TITLE : Changed water selector motor

MODEL : All models with a water selector (*except Aurora and Segó L*)

NUMBER : SI250321

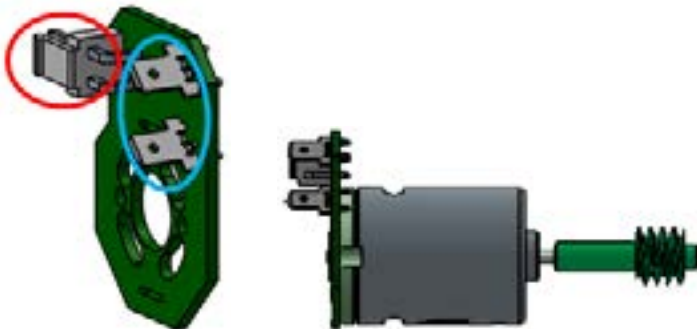
We have added a extra printboard onto the motor with 2 different connections.

- 1 connection is a connection for a connector for new type of machines.
- 1 connection is for 2 loose wires for the older type of machines.

Hereunder the added printboard on the motor water selector with the 2 different connections.

On the left, red circled, the connection for the new type machines.

On the right, blue circled, the connection for older type machines.

The motor water selector can now be used both on older and newer machines as it has 2 different connections.
